# WARNER 4 LOT SUBDIVISION

PCD File No. MS-21-004

Warner Subdivision  
Cover Sheet  
Project No. 2019092  
February 17, 2022  
Sheet 1 of 3

Warner Subdivision  
Lots and Easements  
Project No. 2019092  
February 17, 2022  
Sheet 3 of 3

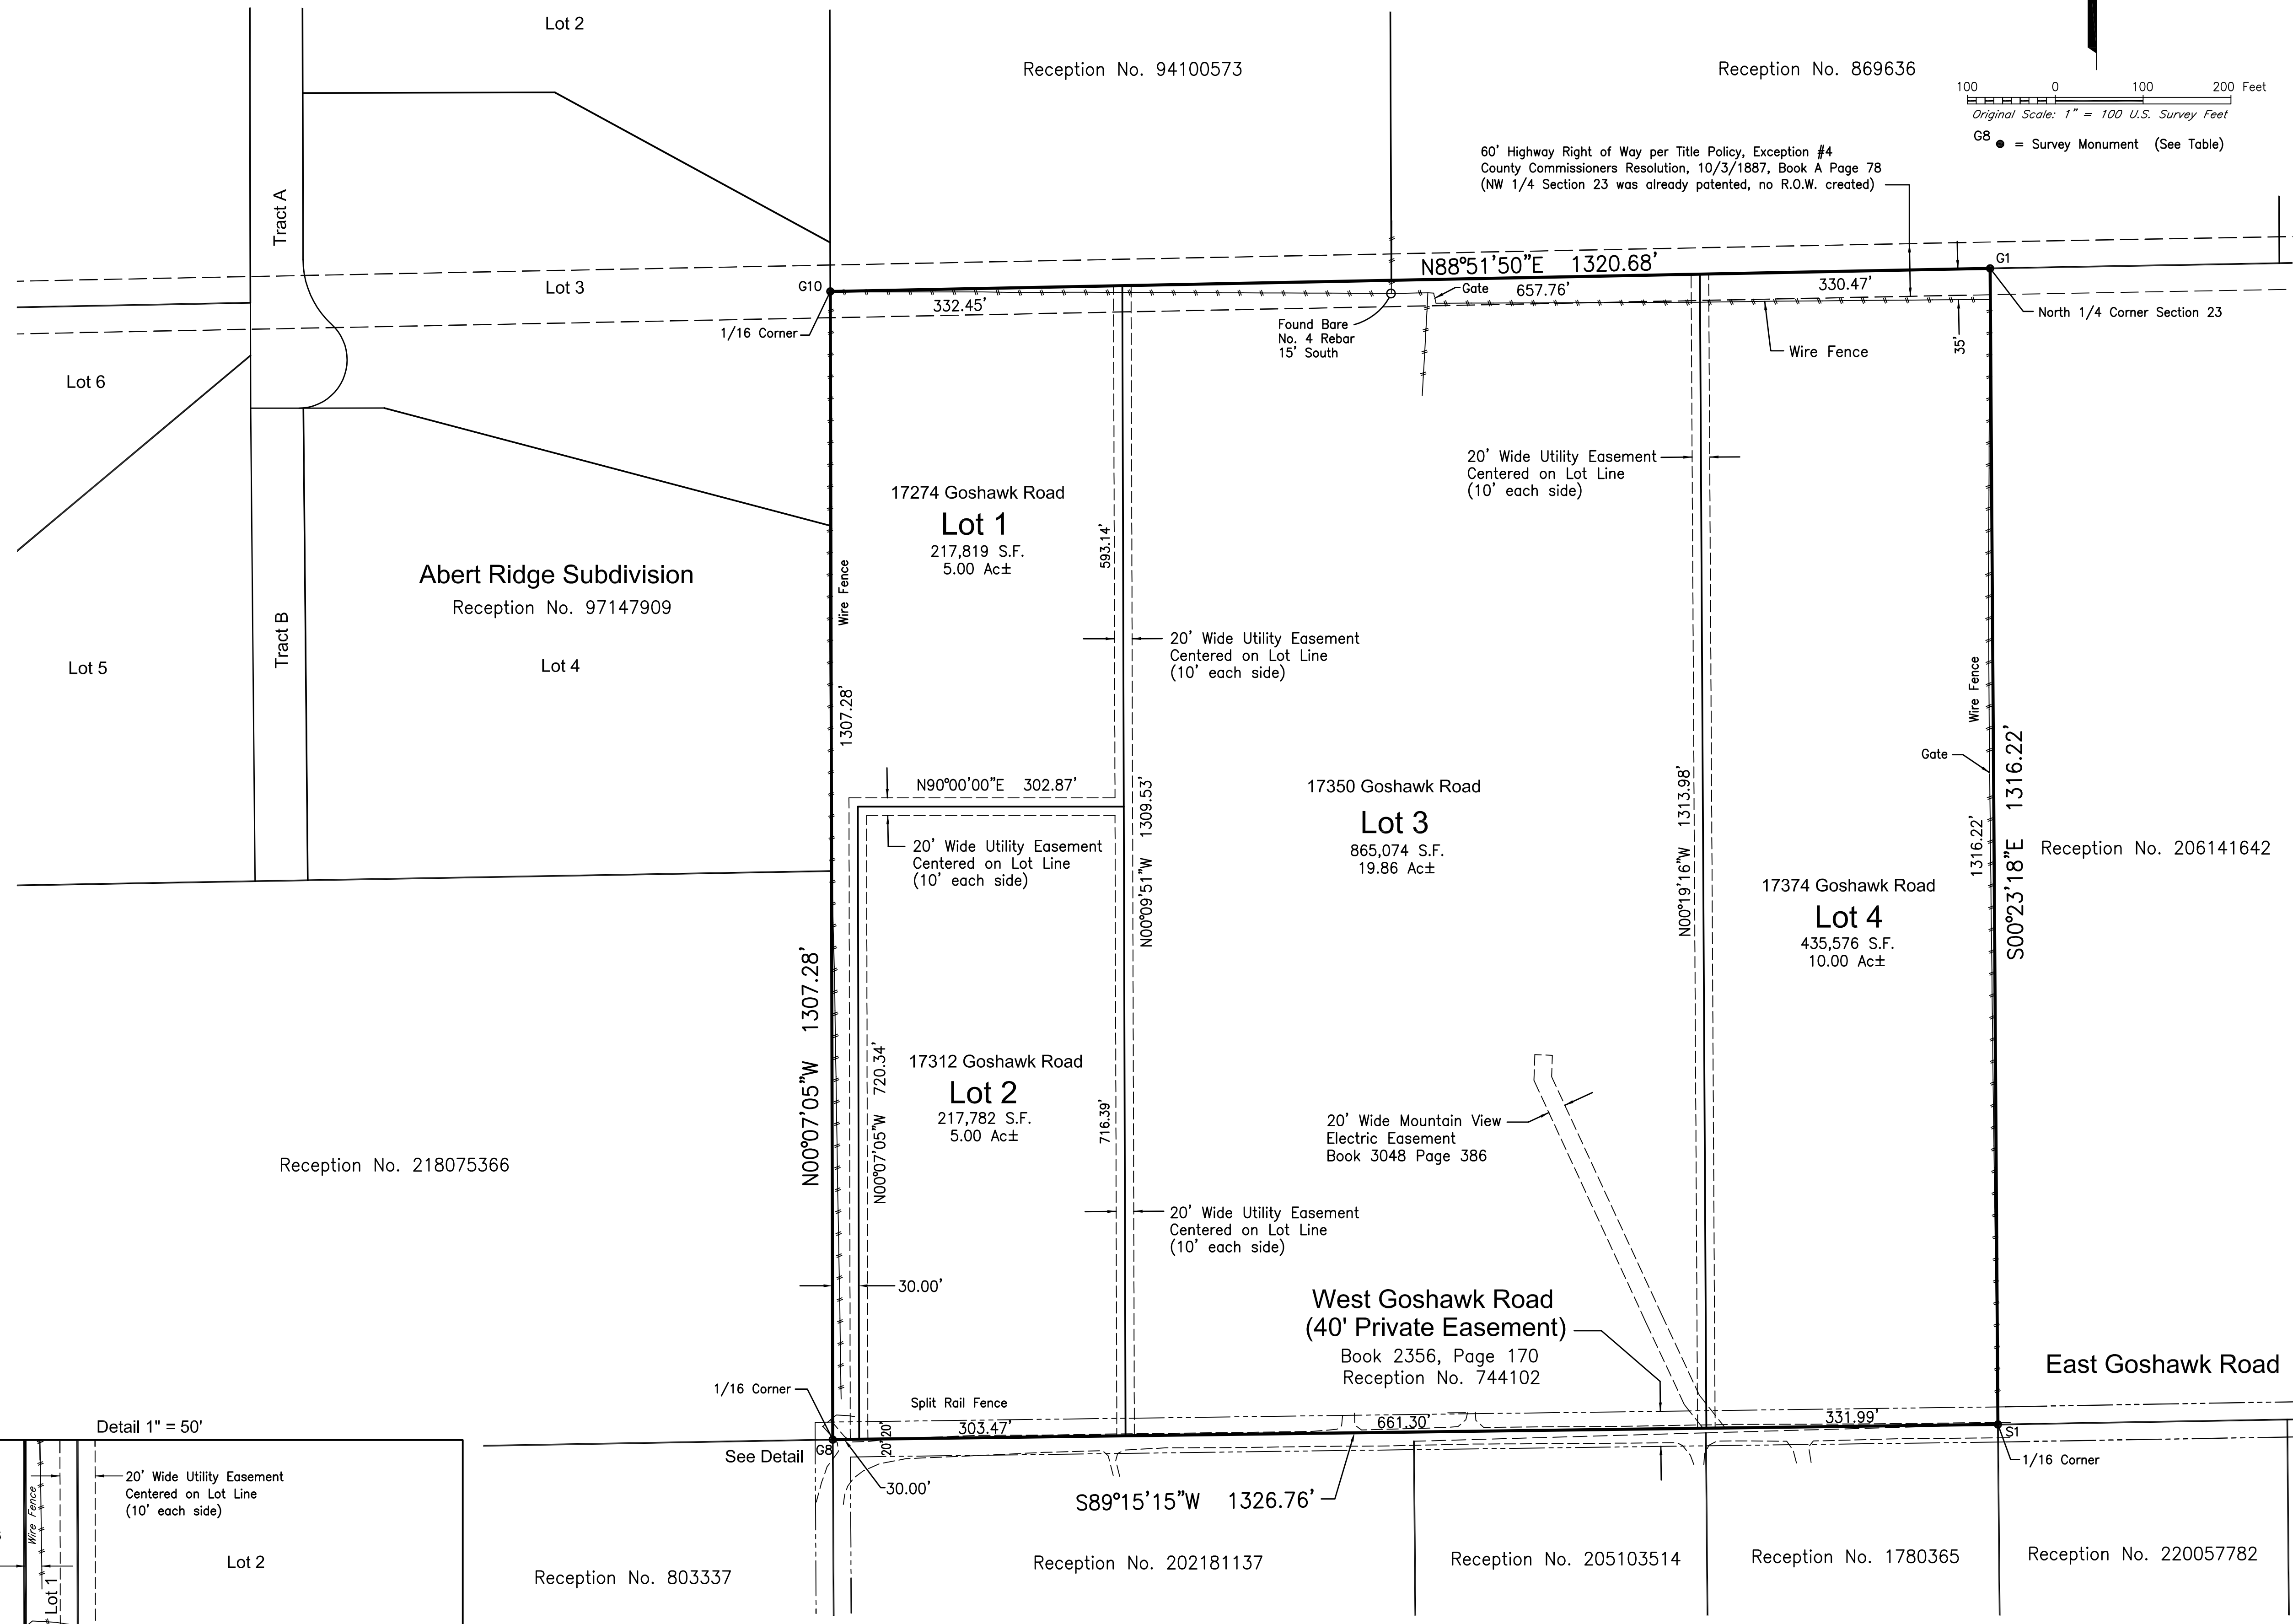
These areas need to be shown on the plat document itself, in addition to detailing the mitigation efforts as part of this note. Please show areas of shallow groundwater on the plat and update note to include mitigation efforts outlined in soils and geo report
